Our Case Number: ABP-316272-23

Re: Bus Connects Templeogue/Rathfarnham to City Centre Core Bus Corridor Scheme
Templeogue/Rathfarnham to City Centre

Bus Connects Templeogue/Rathfarnham to City Centre Core Bus Corridor Scheme

Adrian Young & Nicole Byrne
Woodview Cottages
Rathfarnham

Fig 1.0 TR3 Compound Proposal above and as green space amenity below

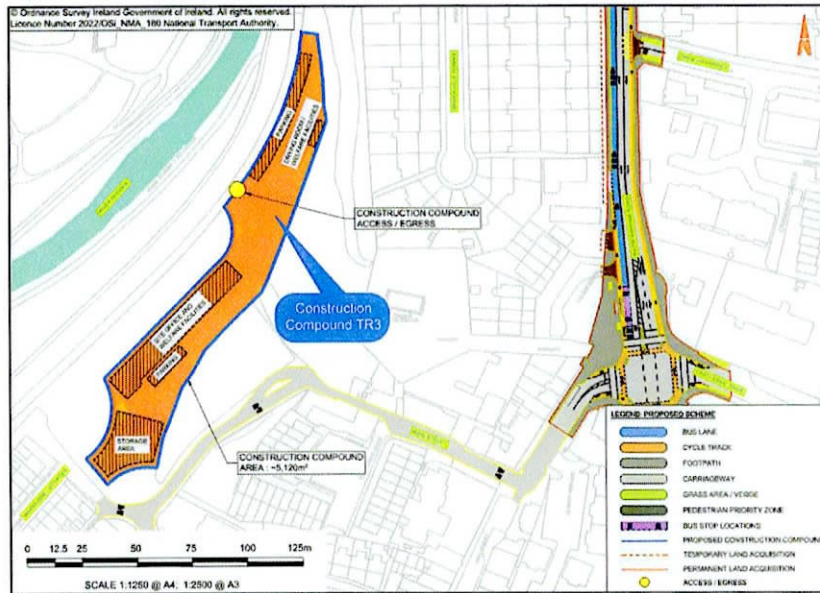
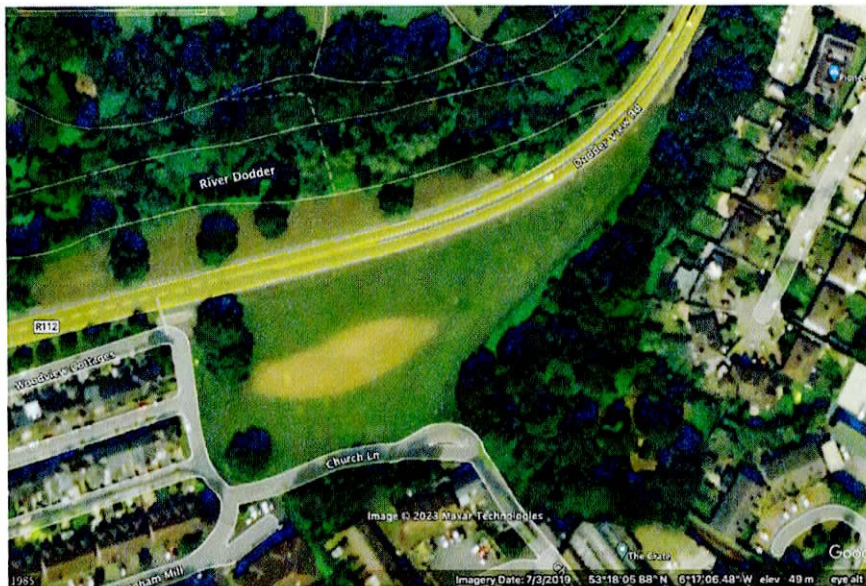
The observation is being made in objection to the location of Construction Compound TR3 Dodder View Road (Fig 1.0 - Image 5.3 from the [Chapter 5 Construction](#)), herein referred to as Site TR3, TR3, Compound, Site) as part of the Templeogue to Rathfarnham Bus Connects Scheme and the Compulsory Purchase Orders of the lands referenced 1004(1).2f as part of the [Compulsory Purchase Orders and Schedule](#). In summary, the site is unsuitable to be used as a construction site for a minimum of 24 months and has been inappropriately selected as the primary construction compound for the Templeogue / Rathfarnham Corridor due to:

- its location directly beside a residential area (within 10m)
- Its location on an Architectural Conservation Area
- the destruction of a green space amenity and community needs and;
- the availability of other more suitable sites in the vicinity

Hazardous materials, as identified in the EIA report and shown in the 'Storage area' of the proposed site map (Fig 1.0), are specifically to be stored at the closest point possible to residential homes, on the southern boundary of the proposed site. Hydrocarbons and other hazardous materials are to be stored here in case of leaks that could cause environmental damage. Instead, *residents* will be exposed to risks including fumes, leaks and fires at the closest point to their homes on the proposed site.

The level of traffic that will be entering and exiting the site will in its own right cause severe disruption and pose a danger to pedestrians and road users (egress noted on Fig 1.0).

Fig 1.3 Site Egress as it currently is for the existing depot

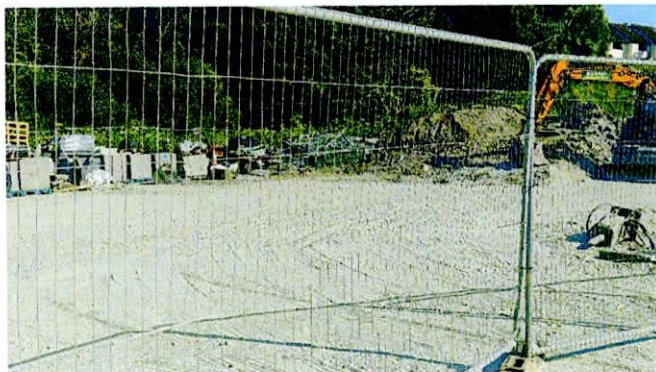
Given the timeline of the proposal, it is likely the site was assessed prior to the completion of the current road works for the Greenway and have not taken into account the narrowed road that is now in place, which is already evidently unsuitable for the use of construction traffic in and out of the existing site.

Fig 1.6

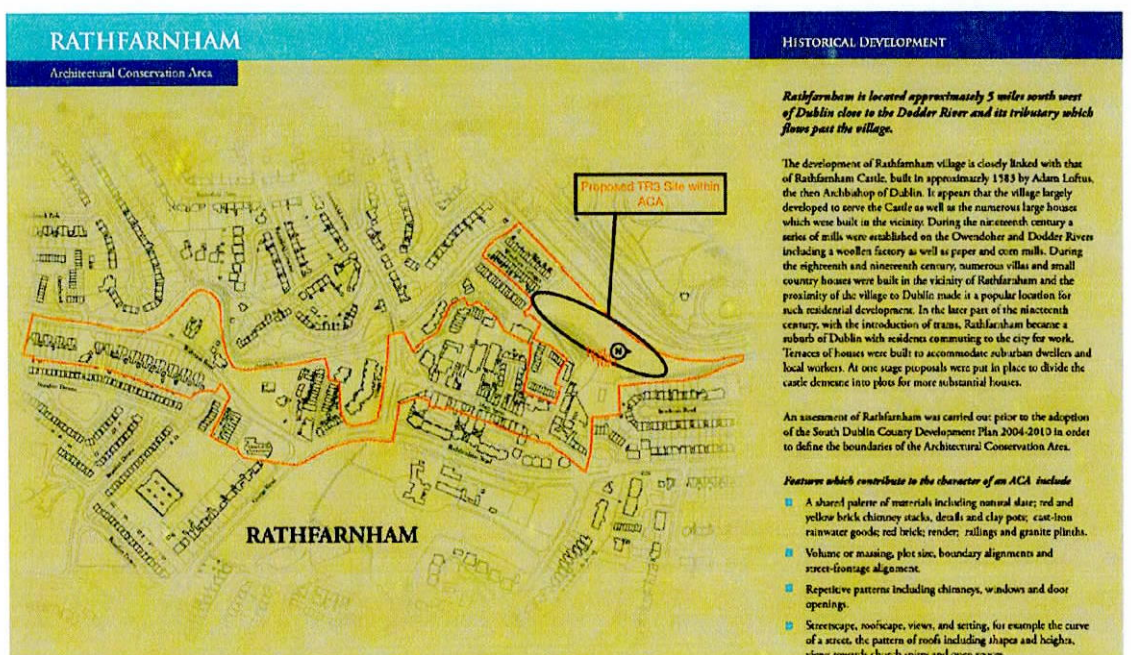
The entire proposed site is within the [Rathfarnham Architectural Conservation Area](#) (ACA) as seen in the Fig 1.6. Regardless of the proposed temporary nature of the site, the *Chapter 15 Archaeology & Cultural Heritage* refers to the TR3 site as having 'no amenity features present'. This assertion is clearly false by virtue of the fact the green space is in itself an amenity feature that is used daily by residents, workers and visitors to Rathfarnham village while the Compulsory Purchase Order (CPO) for the site (Reference: 1004(1).2f) specifically refers to the site description as a 'Recreational Area'.

Primarily, the conditions for a CPO of the lands in the Rathfarnham ACA have not been met as per Section 83 of Planning and Development Act 2000 as the use of the land itself is not part of the development works as outlined in Section 3 and 4 of the Act.

Fig 1.7 - Flood Risk Map - Site TR3

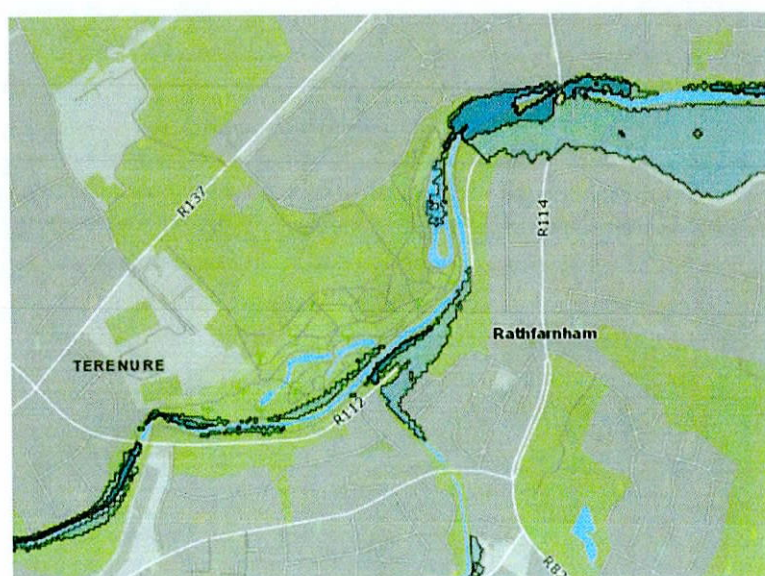
The recreational green area the site is proposed to sit on acts as a drainage sink and is on a flood plain for the Dodder with a [low to medium flood risk](#).

A Flood Risk Assessment for site TR3 has not been undertaken. [The Flood Risk Assessment Document](#) has only reviewed the flood risk of the proposed Bus Connects route and has not undertaken the task of assessing flood risk at construction site TR3, which is not on the Bus Connects route.

Construction sites were not within the scope of the assessment. A Flood Risk Assessment will therefore need to be undertaken to assess the suitability of the Construction sites for their use prior to any further approval, in particular site TR3 that sits on a drainage sink.
